**RE: Storm Water Inspection at Nestle QAC Building Addition/ Franklin County.
Permit #: 4GC04217*AG**

This letter is written in follow up to a construction storm water inspection by Jerome Hoke and Elizabeth Pleta, of the Ohio EPA, at Nestle QAC Building Addition located at 6625 Eiterman Road on September 17, 2013. The purpose of the inspection was to evaluate compliance with Ohio EPA's General Storm Water Permit Associated with Construction Activities. During the inspection, we noted the following:

Figure 1: Sediment basin on site requires a temporary riser and/or skimmer.

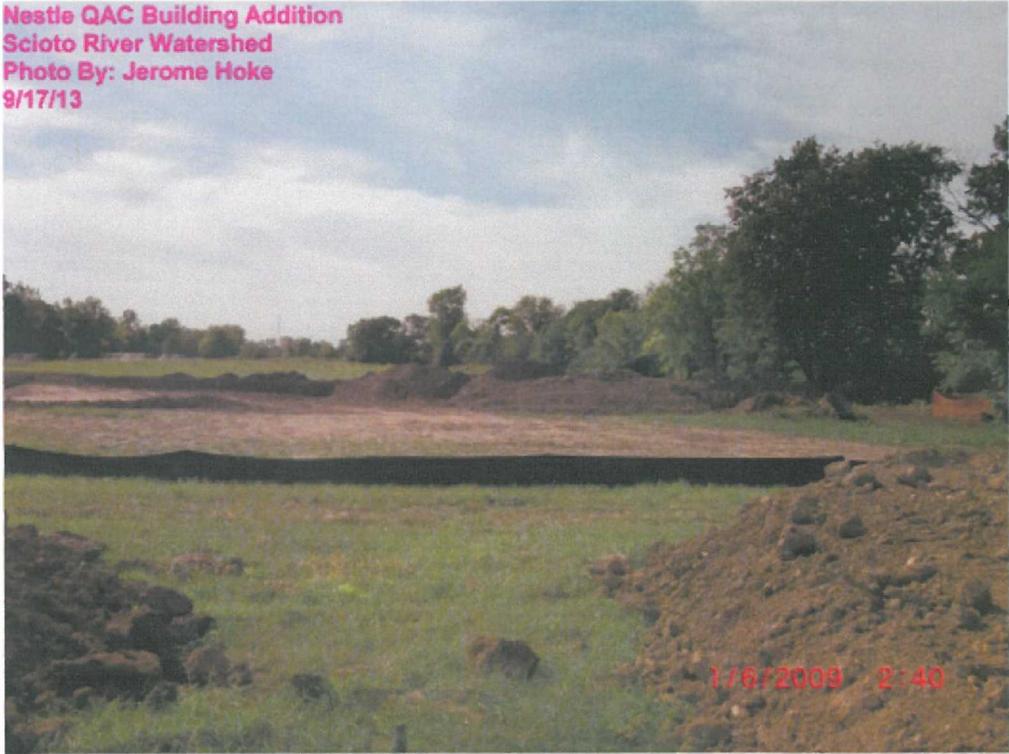
- As noted in our previous inspection, the sediment pond on site lacks a temporary riser and/or skimmer, despite the commencement of major Earth Moving Activities (See Figure 1). The sediment pond requires a temporary riser and/or skimmer within ten (10) days from receipt of this letter or further compliance efforts may be taken on behalf of the Ohio EPA.
- Silt fence is absent adjacent to the stream in the site's extended flood plain (See Figure 2). We discussed with the superintendent on site that, although silt fence along this area was not included in the original site plans, its installation is required to ensure compliance with the General Permit. We also discussed the need to reinstall silt fence on the northeast side of the site that was removed for construction of a headwall. Installation of silt fence is expected within three (3) days from receipt of this letter.
